BURLINGTON DEVELOPMENT REVIEW BOARD Tuesday, February 17, 2015, 5:00 p.m. Conference Room 12, City Hall, 149 Church Street, Burlington, VT AGENDA

AMENDED PUBLIC HEARING NOTICE

From: Mary O'Neil, AICP, Senior Planner

PROPOSED EAST ELEVATION
1/8" = 1'-0"

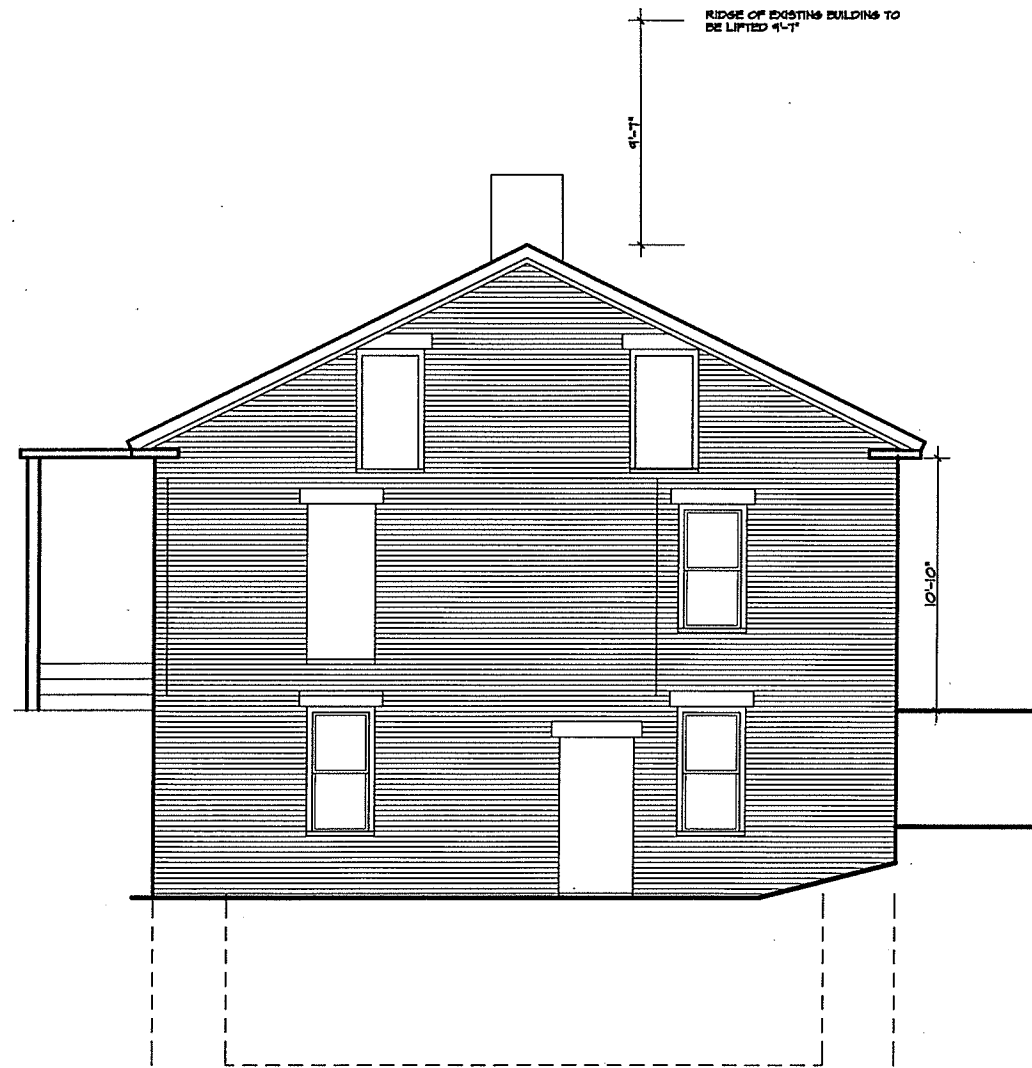
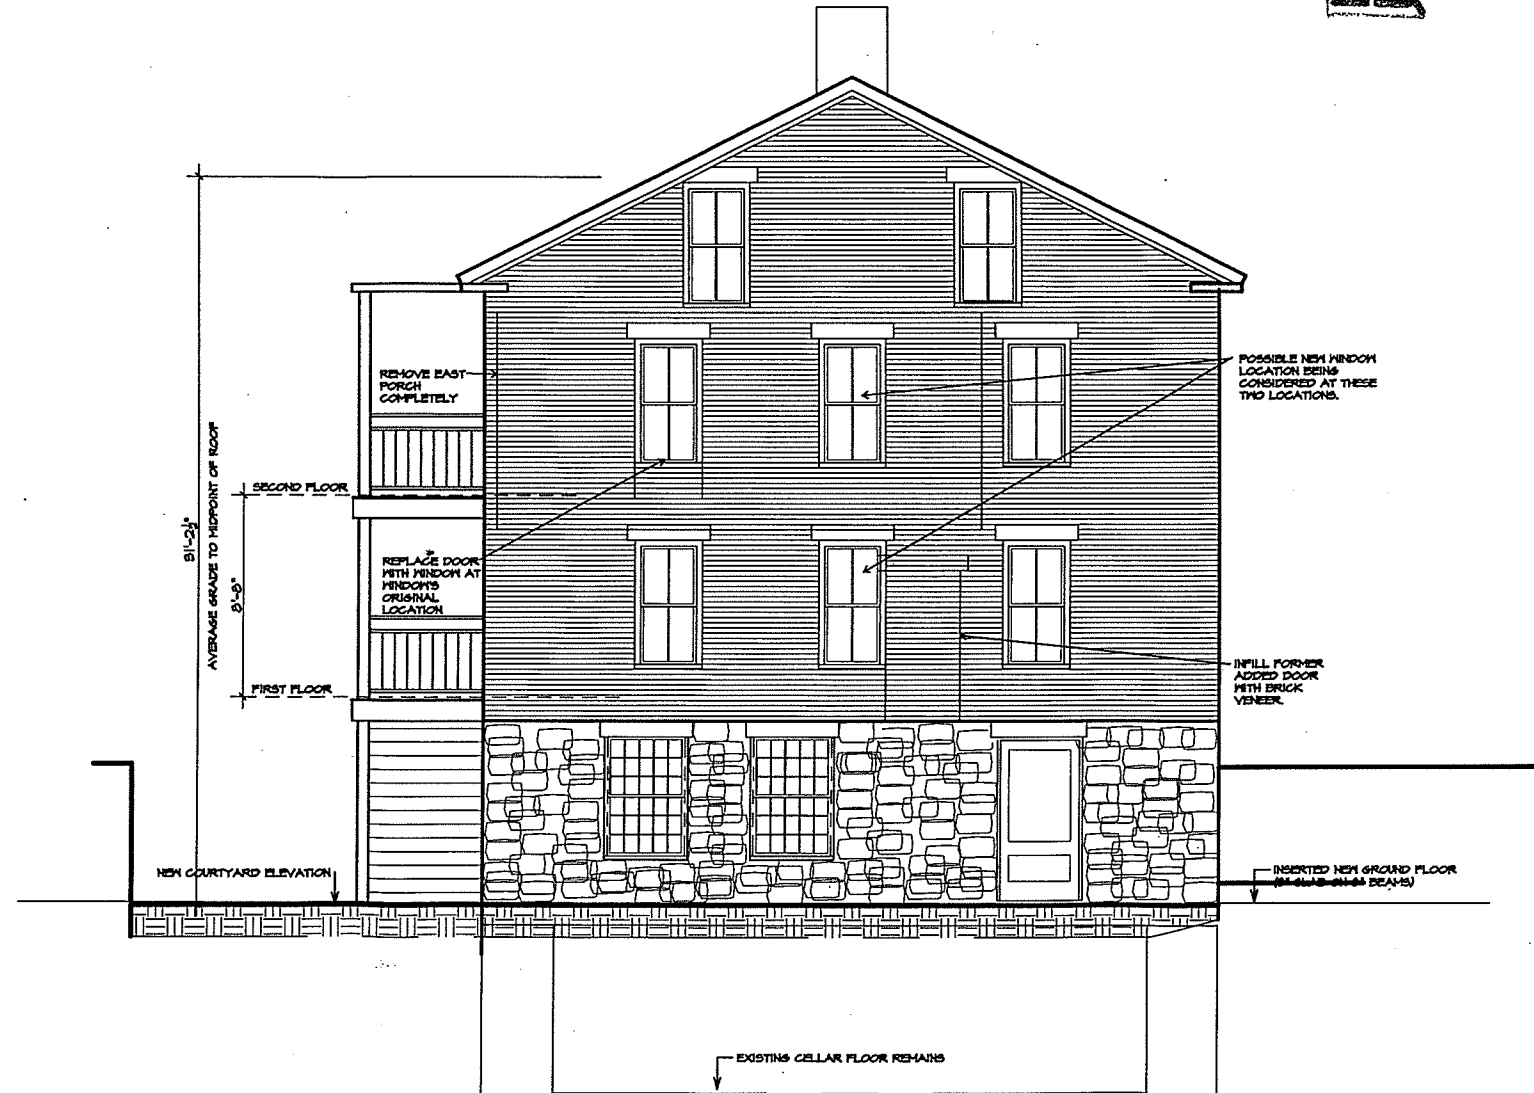
Proposed elevations illustrate 3 ½ stories of exposed structure on the east; something that has not been confirmed as historically accurate. Unless photodocumentation may substantiate the visual qualities that are sought in this application, exposed foundation walls and access entries to the building should not be included in the plan. Other window and door openings are added to support the proposed interior function; however may be considered conjectural without evidence that they originally existed.

The National Register nomination informs that the easterly porch (proposed to be removed) was added between 1906 and 1912. Further investigation as to its integrity should precede consideration of its removal, to determine if its continuance is appropriate for retention of a feature of merit.
